To: All Service Providers
From: M. Angela Foraker, Executive Director
Strategy, Sourcing, & Support
Date: November 4, 2022
Re: Addendum #1 for ITB 21368 – MetroHealth Clinic Upgrades at Clara Westropp, Mound, and Glenville

This Addendum #1 reflects the following:

New MetroHealth
ODH
SBHC
Health Care Expansion Program

Date: 11.04.2022 **A5.0**

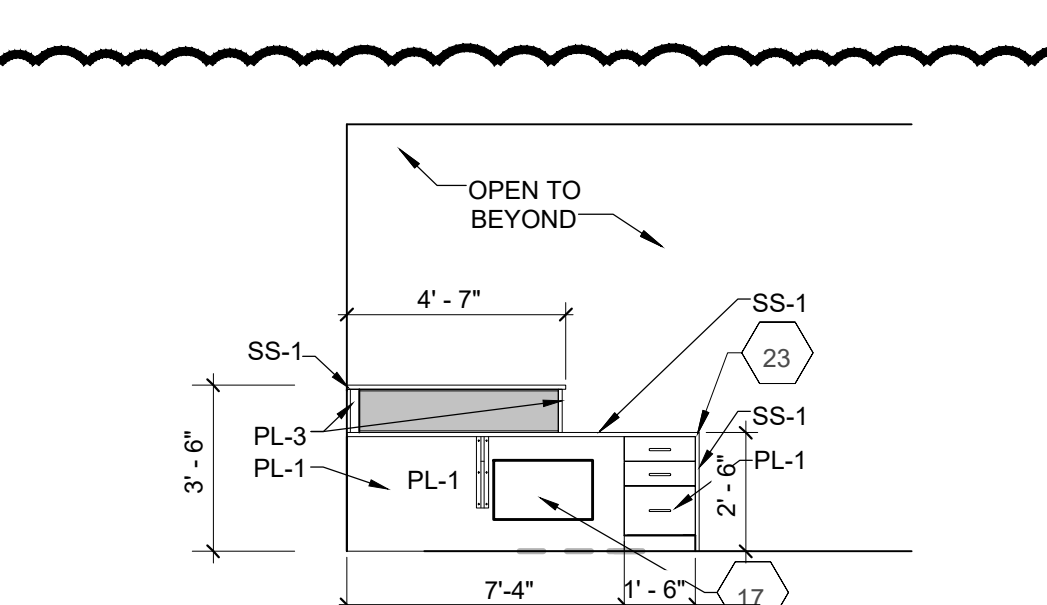
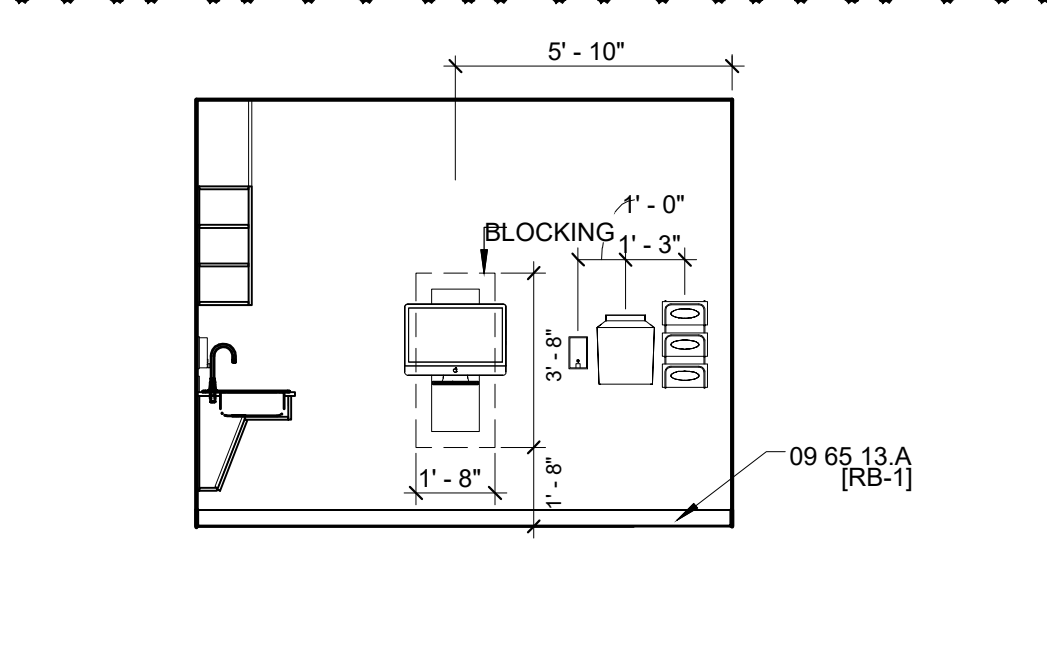
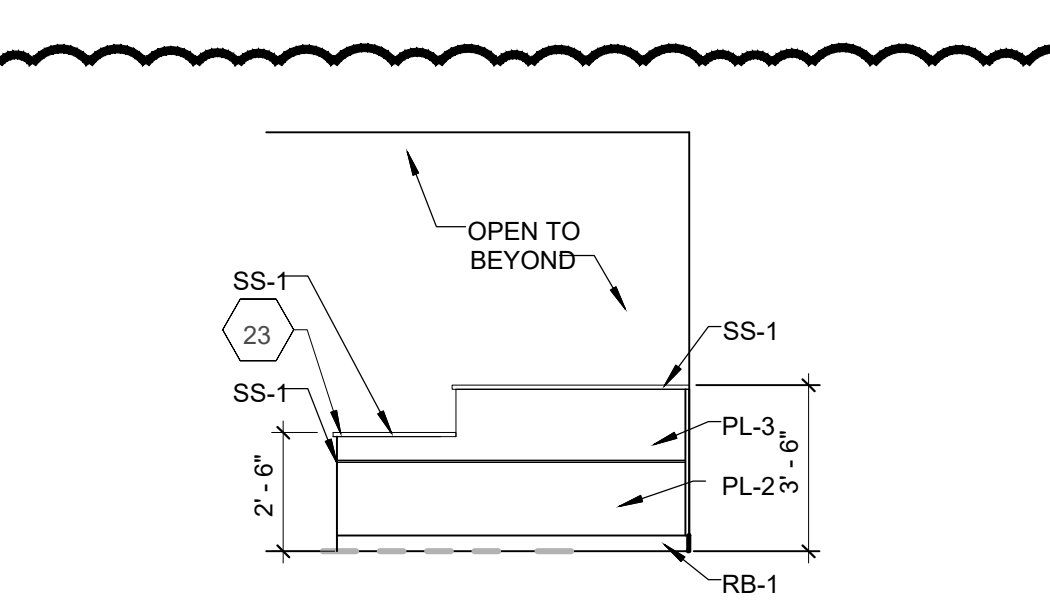
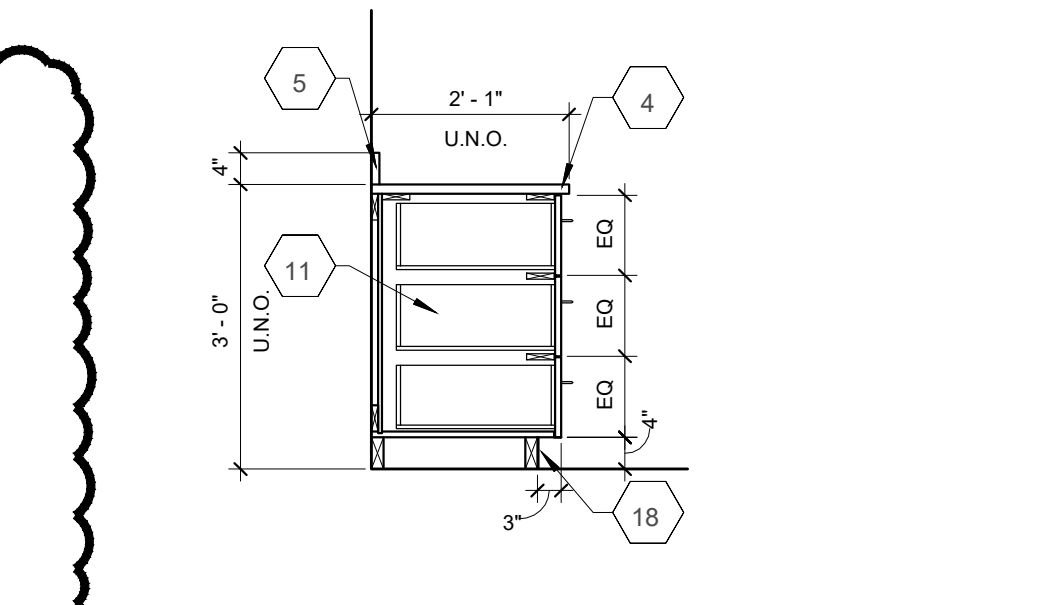
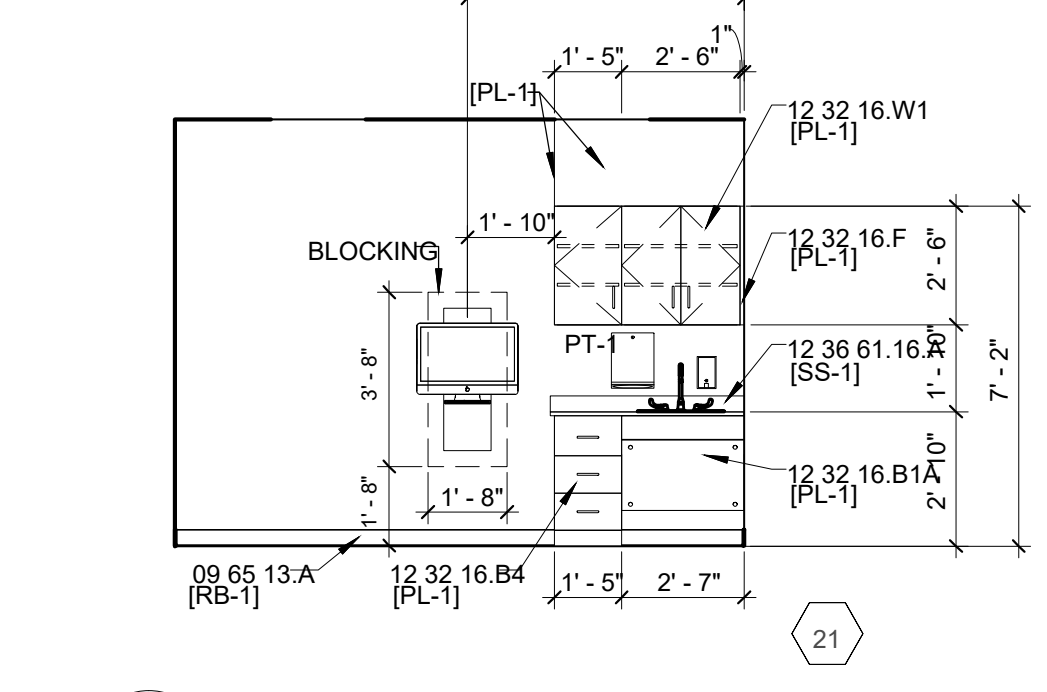
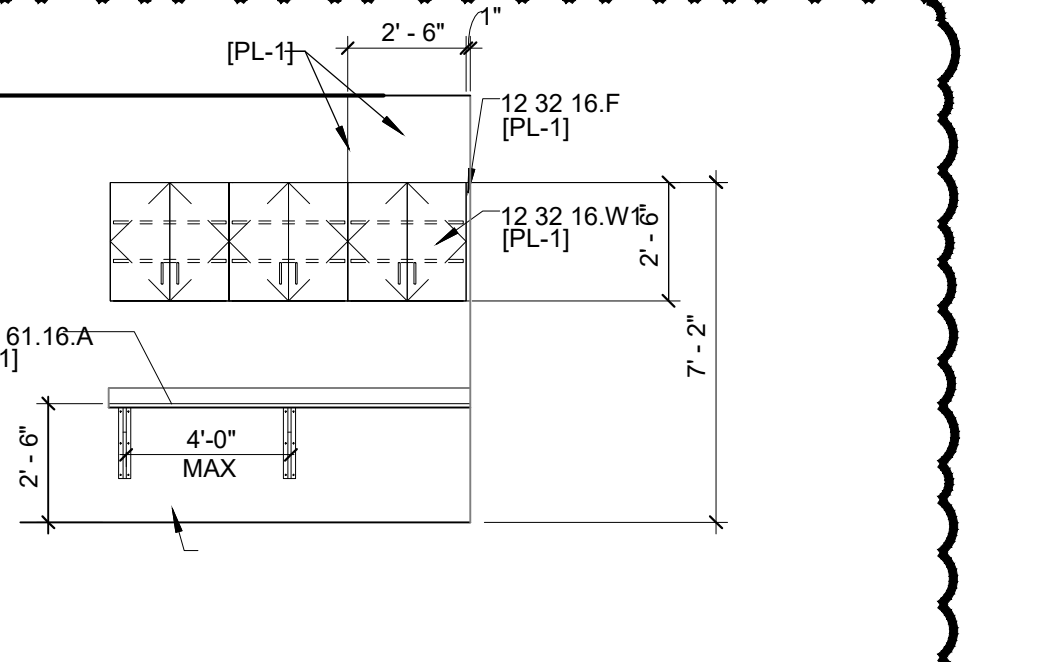
10. On the equipment/furniture plan (A4.0), elevation marker A4/A5.0 is used at the Check In Work Area. That elevation is labeled Staff Break Room and the layout/elevation do not match. What are the casework requirements for this room(Clara Westropp)?

11. Where is elevation B1/A5.0 used(Clara Westropp)?

12. Elevation A3 for Triage/Intake does not match the floor plan layout. What are the casework requirements for this room(Clara Westropp)?

13. Elevation A1/A5.0 does not match the floor plan. The floor plan shows 4 base and 4 wall cabinets, the elevation shows 2 base and 1 wall cabinet. Which is correct(Clara Westropp)?

15. In Check-In 101, the floor plan shows what appears to be a tall cabinet with one base & one wall cabinet next to it. The elevation (A1/A5.0) shows two base and one wall cabinet. Which is correct(Glenville HS)?

See Sheets A4.0 and A5.0 for Revisions

See Sheets A4.0 and A5.0 for Revisions

See Sheets A4.0 and A5.0 for Revisions

See Sheets A4.0 and A5.0 for Revisions

See Sheets A4.0 and A5.0 for Revisions, two base and one wall cabinets
